Access Compliance Report

Public Rights-of-Way

(Curb Ramps)

Intersection ID: 44204	Main Street: MOCKERNUT_DR	Cross Street: COFFEE_TREE_CT	Location: NE
ADA ID: 7D4157B245A6	Ramp Type: PerpDiag	Initial Pass/Fail: Fail	Overall Compliance: No
		Severity Score: 10

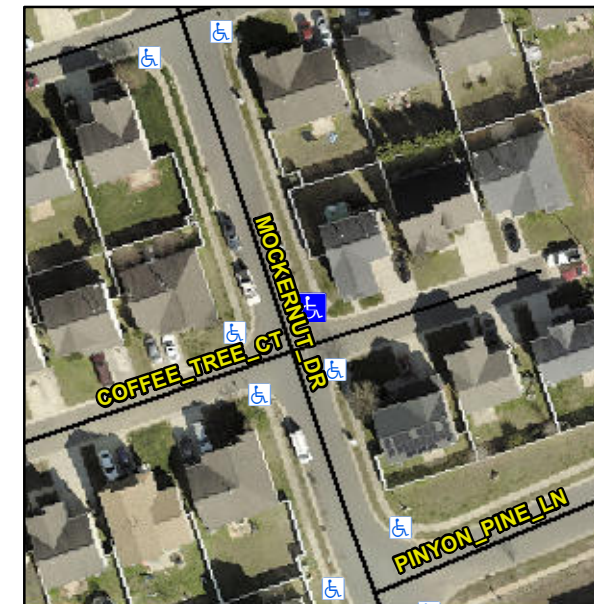
Not Found, R304.5.1, R304.5.3

Compliance	Description	Data	Compliance	Description	Data
N/A	Ramp Length (in)	51.0	Yes	Ramp Slope (%)	5.4
No	Ramp Width (in)	45.0	No	Ramp XSlope (%)	4.3
N/A	Flare Type LT	N/A	N/A	Flare Type RT	N/A
N/A	Flare Slope LT (%)	N/A	N/A	Flare Slope RT (%)	N/A
N/A	Flare Traversable LT?	N/A	N/A	Flare Traversable RT?	N/A
N/A	Landing Length (in)	N/A	N/A	DWS Provided?	N/A
N/A	Landing Width (in)	N/A	N/A	DWS Contrast?	N/A
N/A	Landing Slope (%)	N/A	N/A	DWS Length (in)	N/A
N/A	Landing X Slope (%)	N/A	N/A	DWS Full Width?	N/A
N/A	Landing Curb? (Y/N)	N/A	N/A	DWS Offset (in)	N/A
N/A	Shared Landing?	N/A			
N/A	Gutter Ponding?	N/A	N/A	Gutter Slope (%)	N/A
N/A	Gutter Lip Ht (in)	N/A	N/A	Gutter X Slope (%)	N/A
N/A	Painted X Walk1?	No	N/A	Painted X Walk2?	No
	X Walk 1 Direction	To W		X Walk 2 Direction	To S
N/A	X Walk 1 Width (in)	N/A	N/A	X Walk 2 Width (in)	N/A
	X Walk 1 Slope (%)	4.6		X Walk 2 Slope (%)	5.9
	X Walk 1 X Slope (%)	3.8		X Walk 2 X Slope (%)	0.5

Remove & Replace Curb Ramp With Two New Directional Ramps or Equivalent.
